UNITED STATES PATENT AND TRADEMARK OFFICE

Office Action Summary

10/671,928

DETAILED ACTION

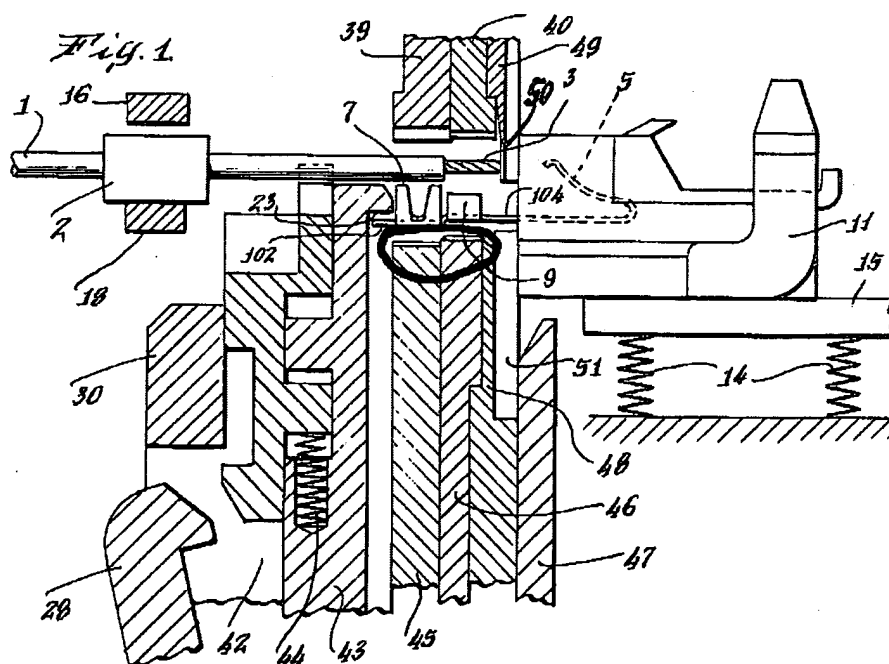
b. Regarding claim 2, (as best understood), Wigby et al. disclose the same invention as the applicant, including a wire termination apparatus wherein a terminal placed on an anvil and having a conductive lead inserted in an insertion hole of the terminal is crushed by a crimper, thereby terminating the conductive lead (see Fig. 2)

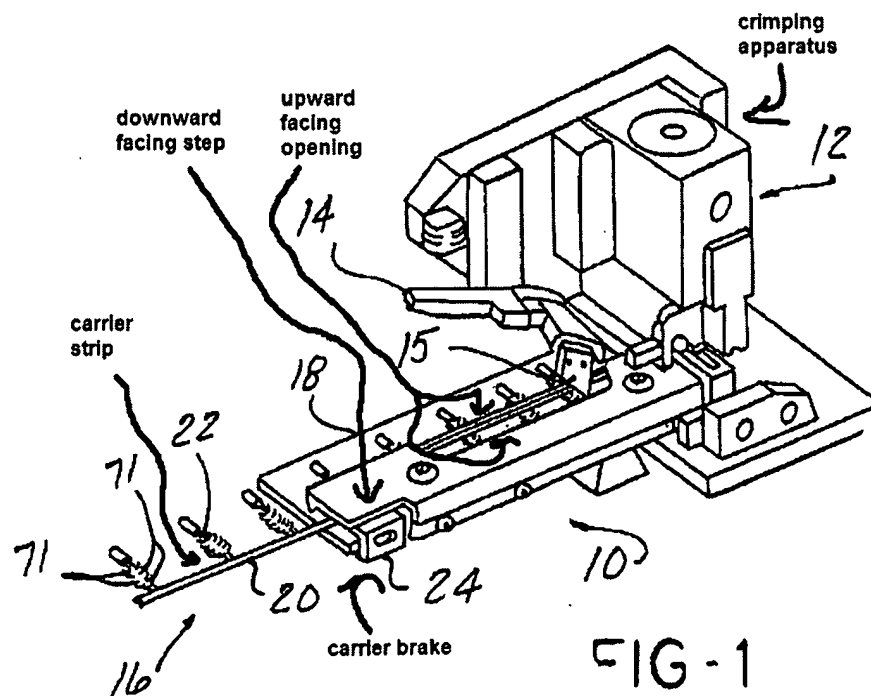
Wigby et al. disclose the same invention as the applicant, except for a rail for guiding successive collapsible terminals mounted on a carrier strip onto an anvil wherein the rail has a downward facing step for retaining the carrier strip and an upward facing opening to accommodate the collapsible terminals and wherein a carrier brake is mounted on the rail and biased into frictional contact with the carrier strip.

Baldyga teaches these limitations. See col. 2, Ins. 50-55 as well as the image below.
